R26DY

DATE: August 6, 2026
TO: Blue Bird Owners
Subject: R26DY: Electric Vehicles May Shut Down

IMPORTANT SAFETY RECALL

SUBJECT: R26DY: Electric Vehicles May Shut Down

Figure 1

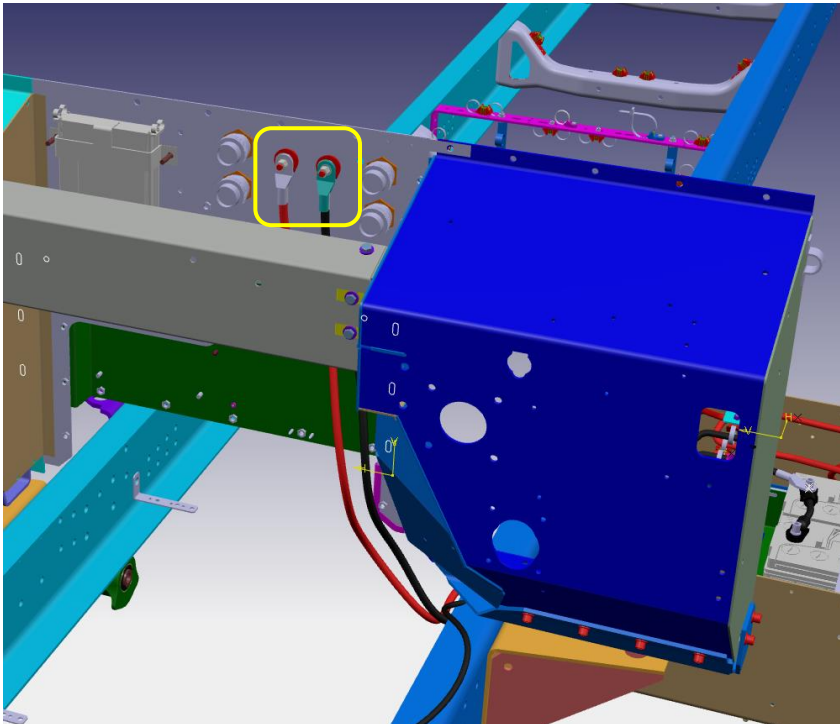
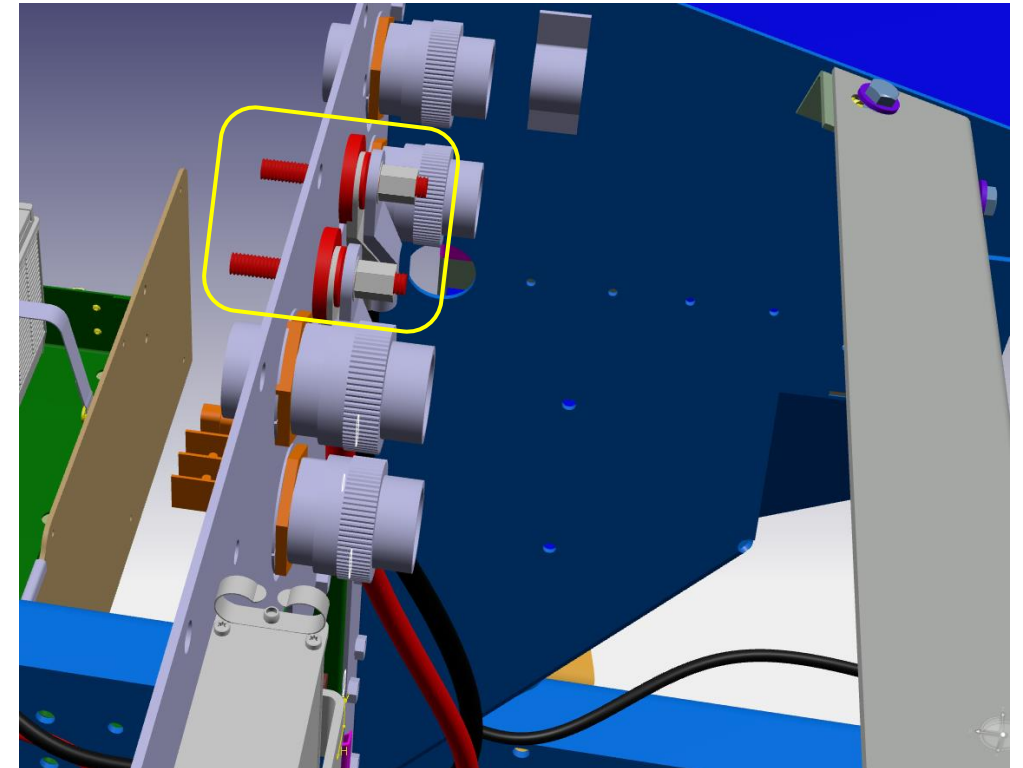
1. Remove negative battery cable from 12v Battery bank and secure.
2. Replace both positive and negative DCM pass through studs. (See Figure 1 & 2)
3. Service locations highlighted in Figures 4 - 7. Any connections/components found to have any thermal stress MUST be replaced.
4. Clean/prep connection(s) per Figure 3, and torque per legend on Page 2.

Figure 8

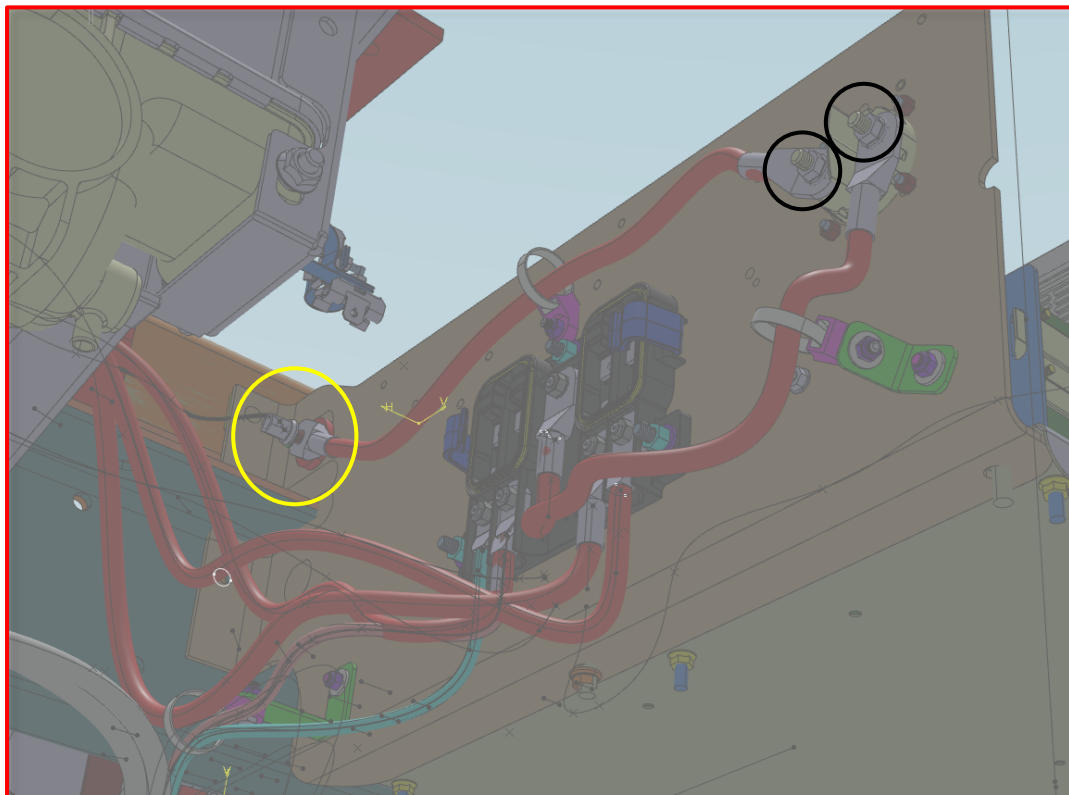
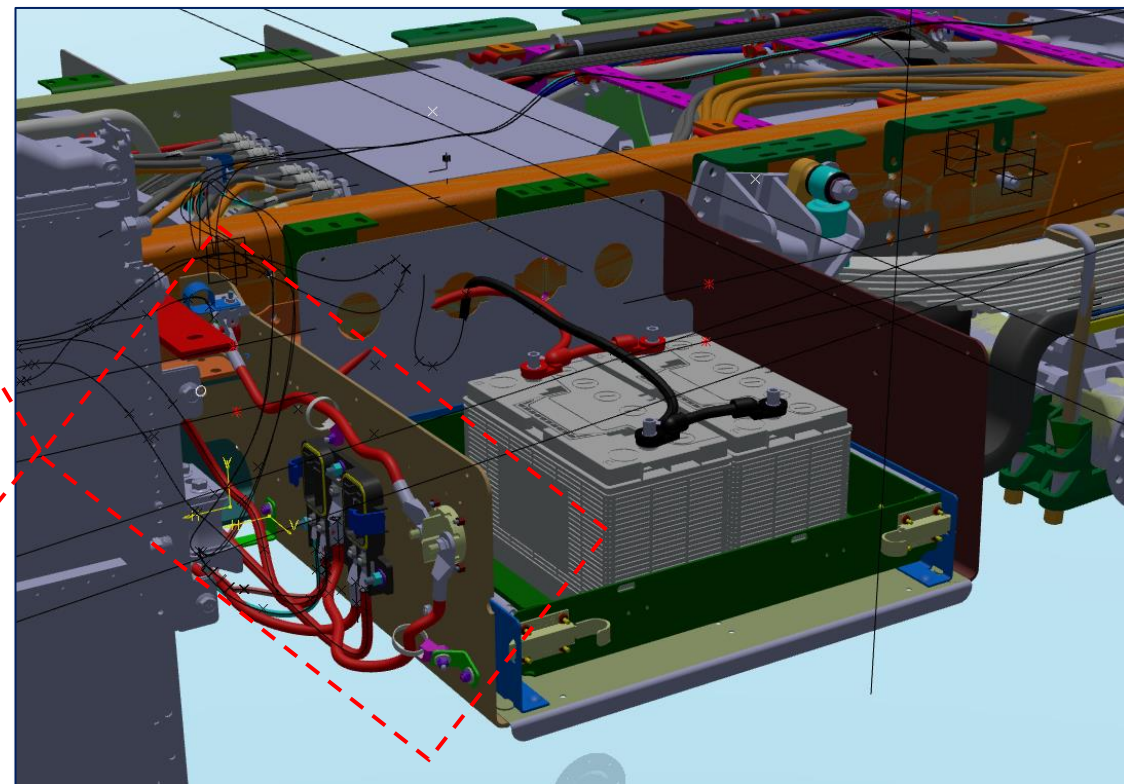
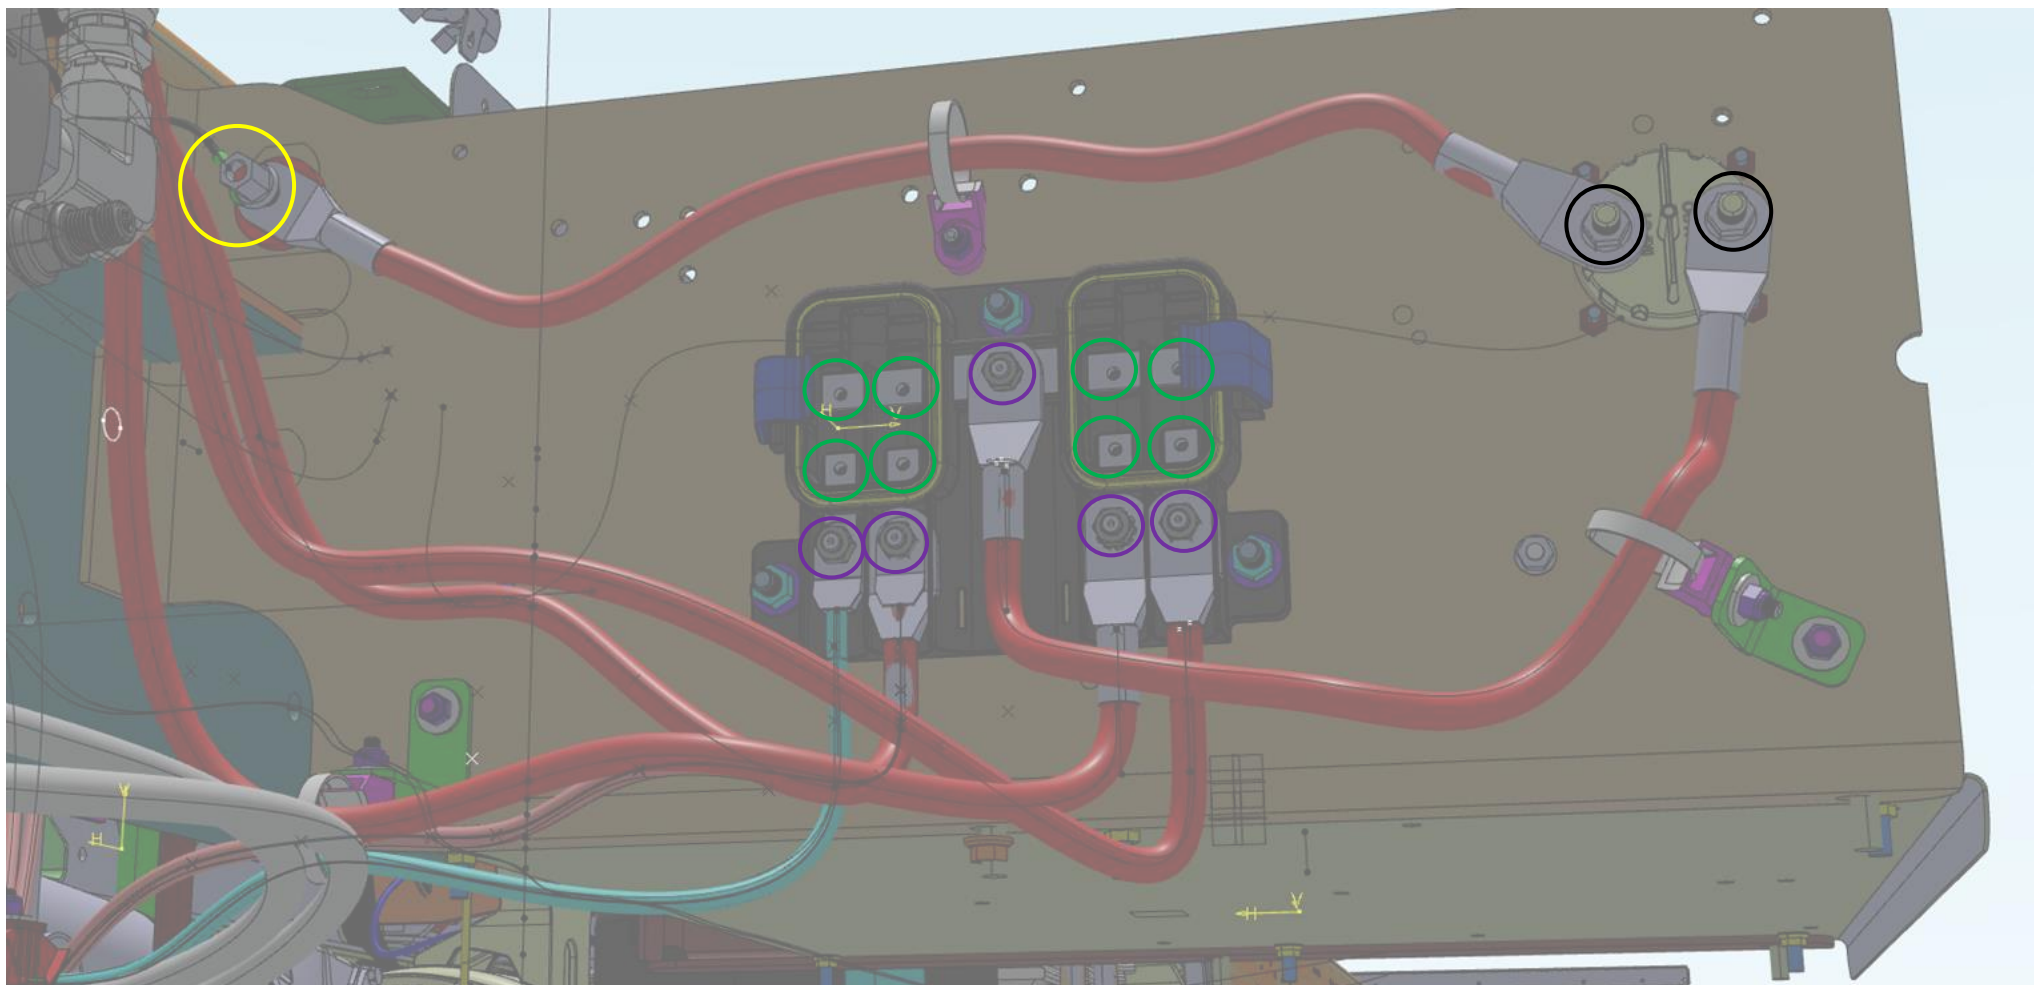
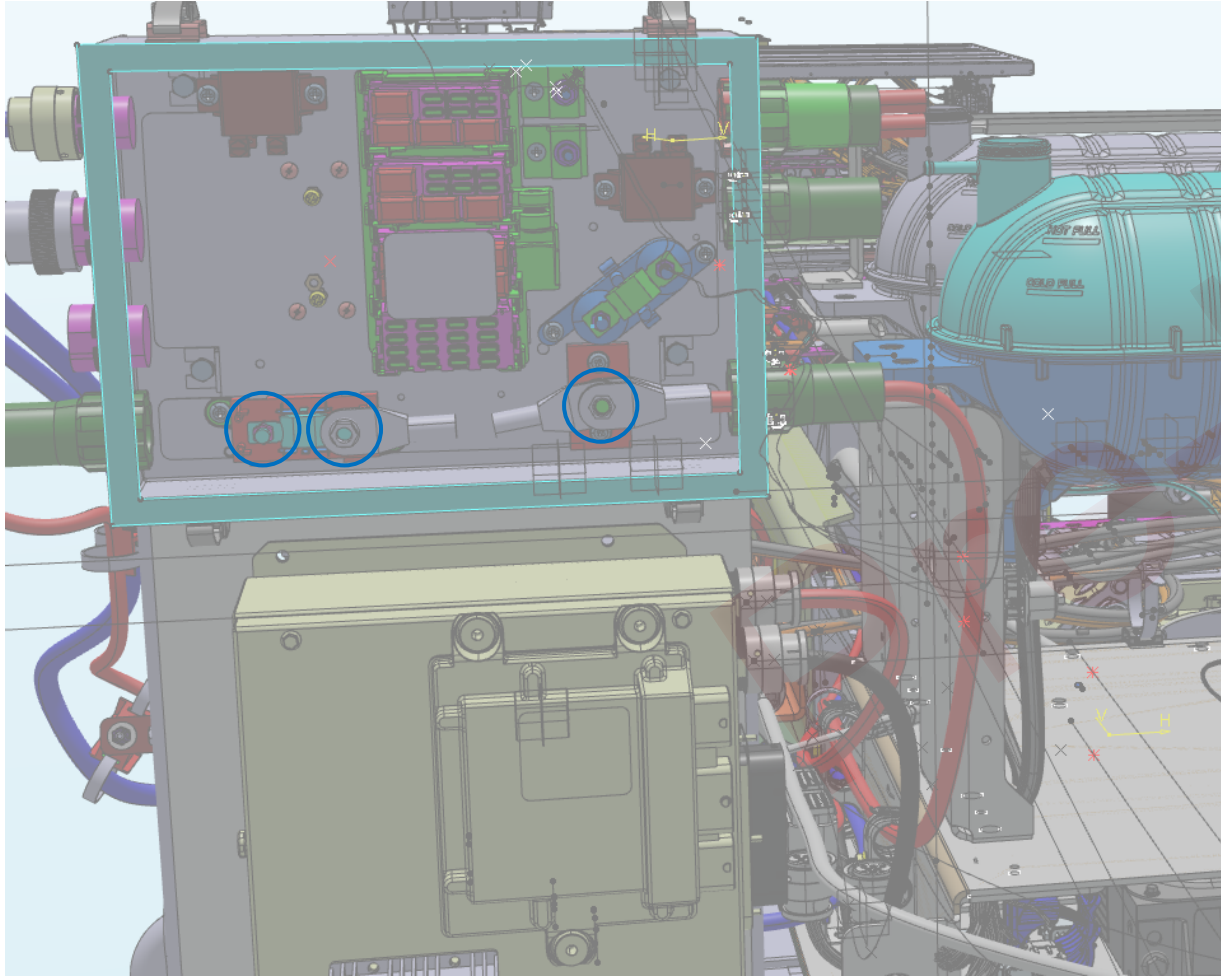
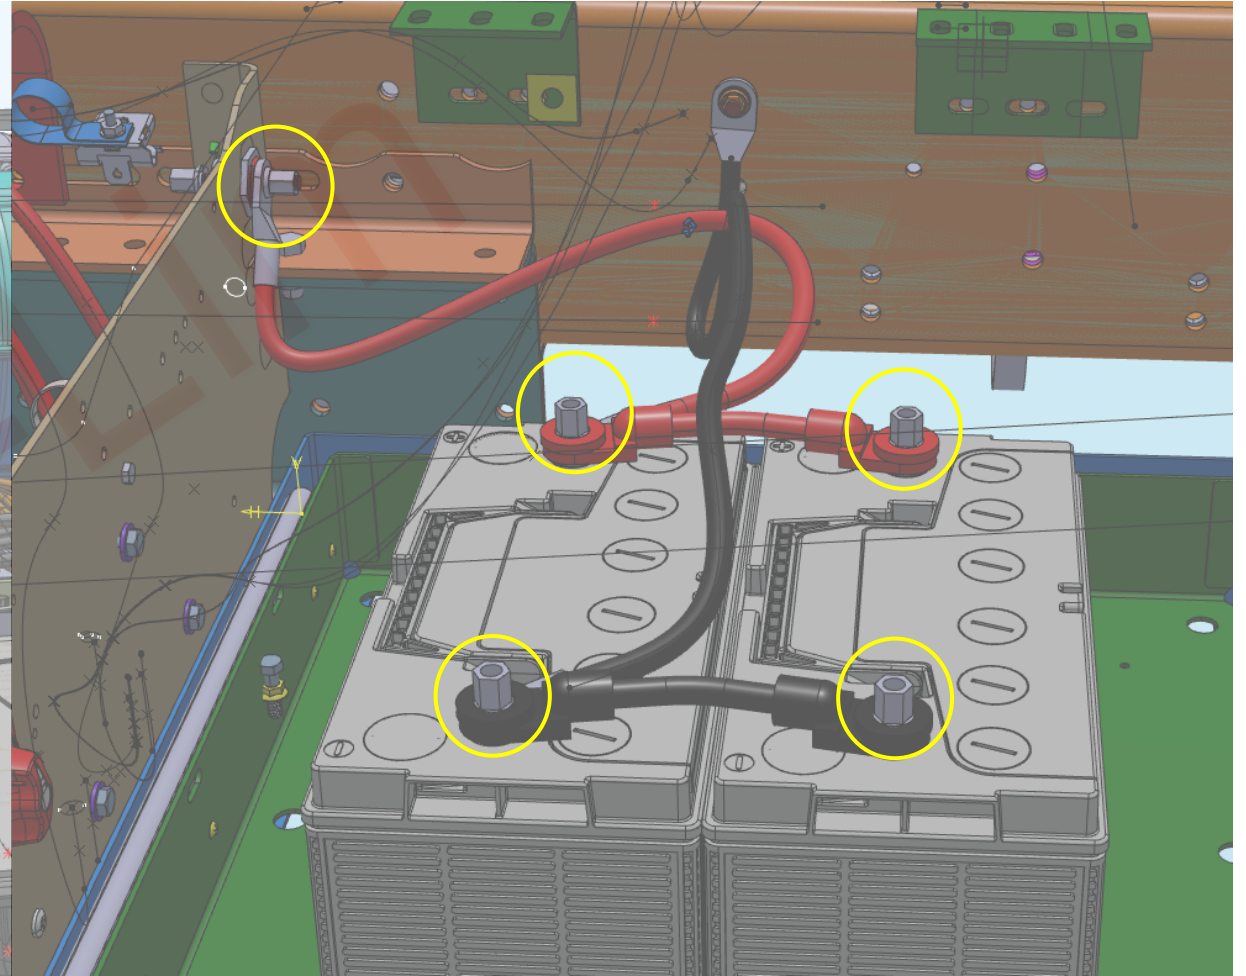
1. Remove negative battery cable from 12v Battery bank and secure.
2. Service locations highlighted in Figures 8 - 12. Any connections/components found to have any thermal stress MUST be replaced.
3. Clean/prep connection(s) per Figure 3, and torque per legend on Page 2.

Figure 12

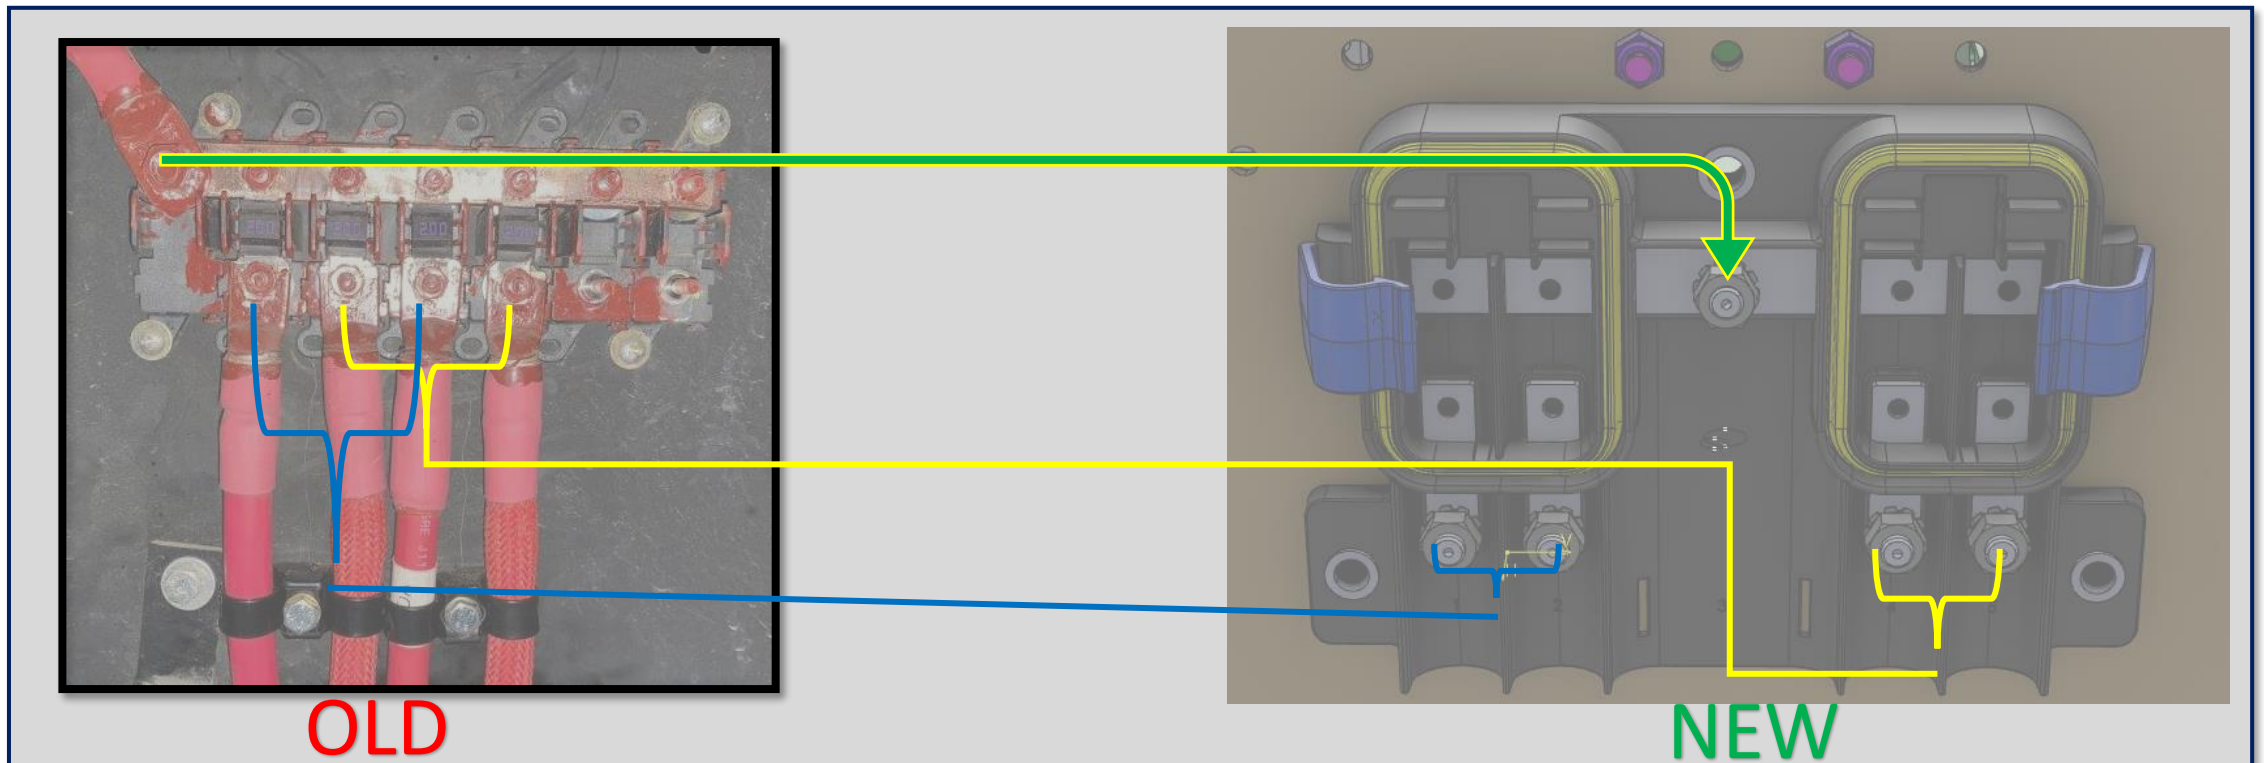
1. Remove battery negative cable and secure.
2. Remove all chassis cables from original BPDA and prep per Figure 3
3. Remove BPDA assy and install new BPDA per Figure 12
4. Torque connections on new BPDA per Figure 6
